HRRV LP GAS LINE RECALL 14V-254

REV										OR OPEN RANGE RV COMPANY 3055 N. 28th SHOPSHEVANA, IN 46563	
I										DESCRIPTION GAS LINE CHANGE	
S										MATERIAL --	
D										FILE WARRANTY & SERVICE	
N										DRAWING NUMBER --	
①										REV --	
MODEL		UF319		DRAWN BY		DUESLER		DATE		5/28/14	
				SHEET		1 OF 2		MODELS

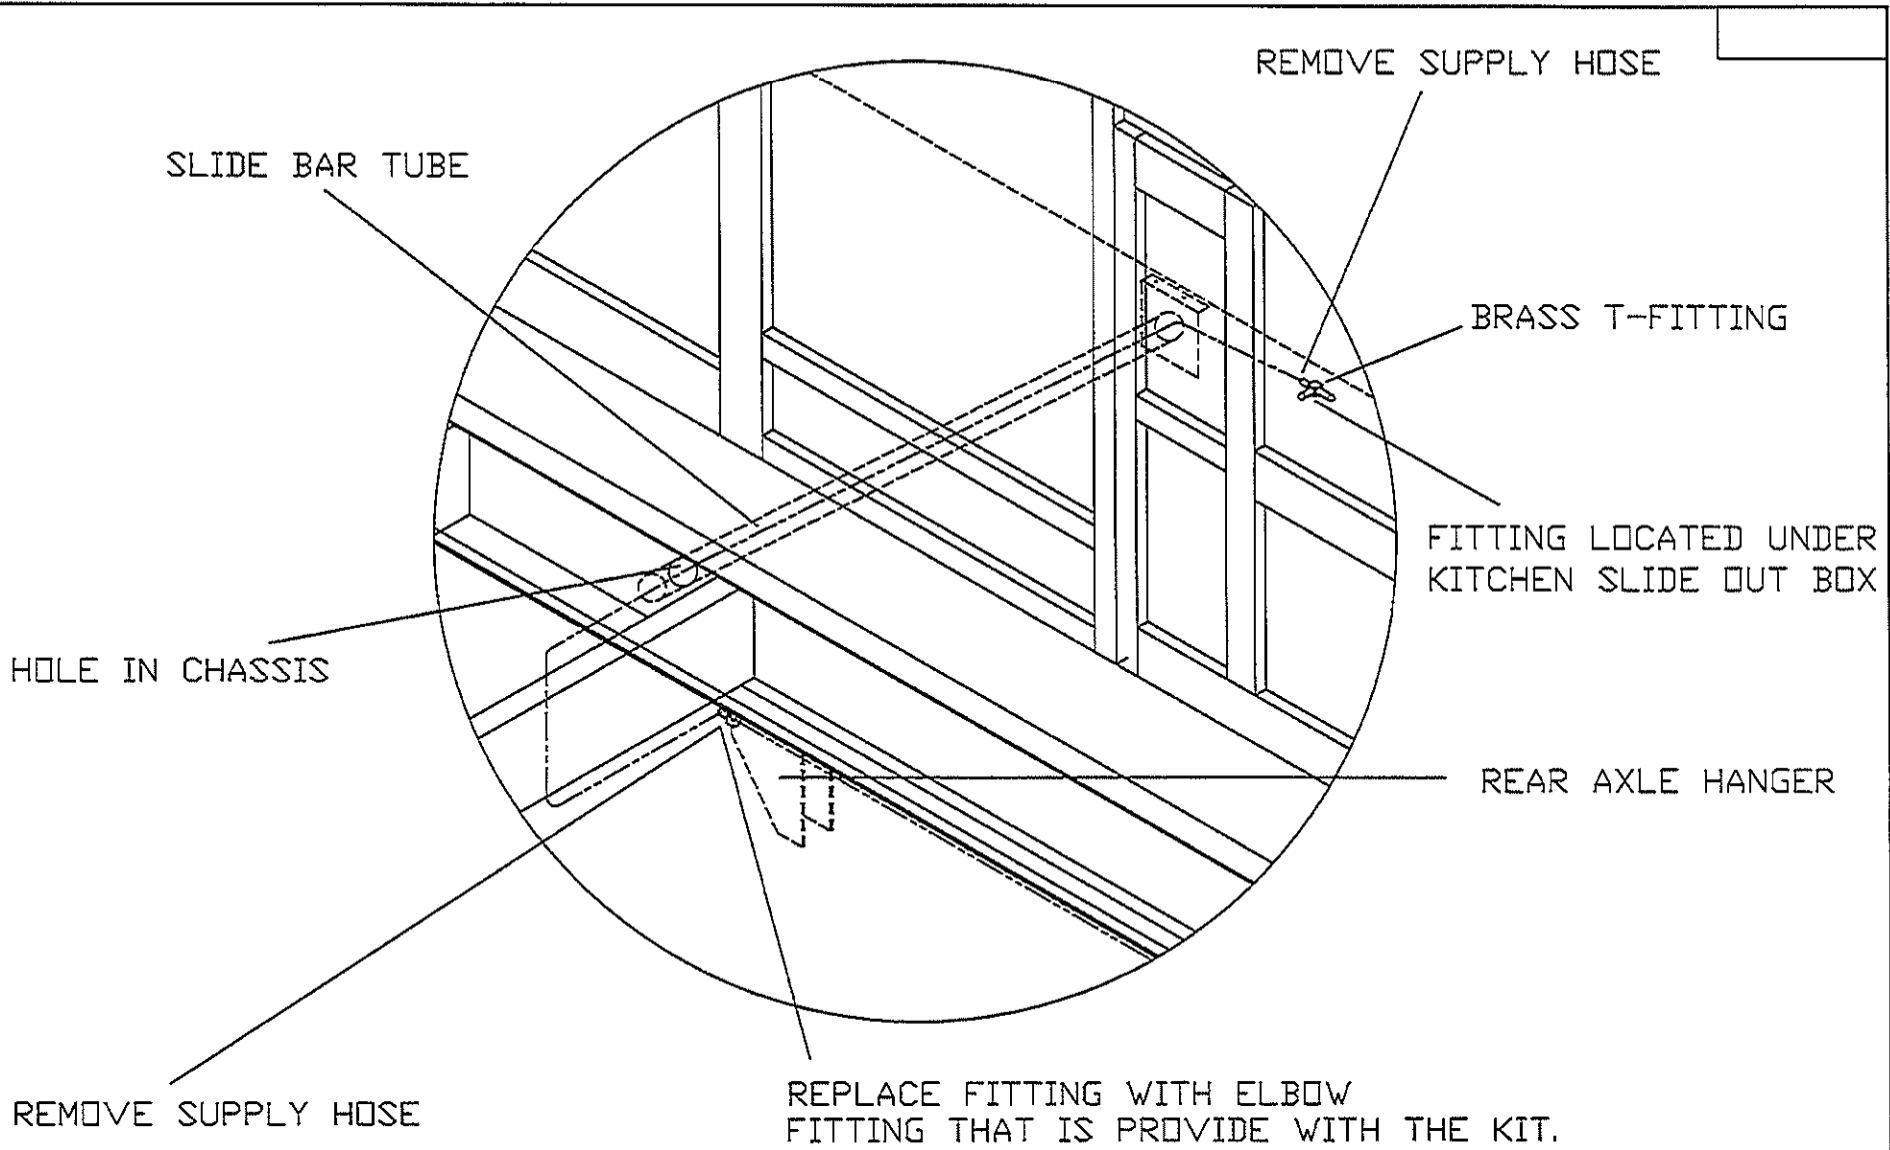
- 1) REMOVE RUBBER GAS SUPPLY LINE FROM FITTING UNDER THE KITCHEN SLIDEOUT. THEN REMOVE THE GAS SUPPLY LINE FROM THE BRASS FITTING LOCATED BY THE TIRE ON THE OFF DOOR SIDE OF THE COACH. LOWER JUST ENOUGH OF THE UNDERBELLY MATERIAL (2-3ft) TO REACH INSIDE AND HELP FEED THE HOSE BACK THROUGH THE PIPE.

- 2) ATTACH THE NEW RUBBER GAS SUPPLY LINE TO THE OLD RUBBER GAS SUPPLY LINE, AND PULL THE LINES THROUGH THE PATH OF THE CURRENT LINE. WHEN THE NEW RUBBER GAS LINE HAS COME THROUGH, DISCONNECT THE 2 LINES FROM EACH OTHER.

- 3) LOOSEN 3 PIPE CLAMPS STARTING AT THE BRASS FITTING THE RUBBER GAS SUPPLY LINE WAS CONNECTED TO BY THE TIRE. THE GAS LINE SHOULD BE LOOSE ENOUGH TO REMOVE THE BRASS FITTING. AFTER REMOVAL OF THE BRASS FITTING, APPLY PIPE COMPOUND TO THE ELBOW FITTING THAT WAS SUPPLIED WITH THE REPAIR KIT, AND ATTACH TO MAIN GAS LINE ALONG CHASSIS.

- 4) CONNECT THE RUBBER GAS SUPPLY LINE TO THE BRASS T-FITTING THAT IS UNDER THE SLIDEOUT, AND CONNECT THE OTHER END TO THE ELBOW FITTING, INSTALLED IN THE LAT STEP, LOCATED ON THE CHASSIS FRAME RAIL.

- 5) AFTER CONNECTIONS ARE MADE, DROP PRESSURE TEST THE LP SYSTEM TO RVIA REQUIREMENTS.
- 6) AFTER THE LP SYSTEM TEST MEETS THE RVIA REQUIREMENTS, THEN REATTACH THE UNDERBELLY MATERIAL, AND RESEAL.

- 7) **THE OLD RUBBER GAS SUPPLY LINE NEEDS CUT IN HALF AND DISCARDED SO IT CANNOT BE USED AGAIN.**
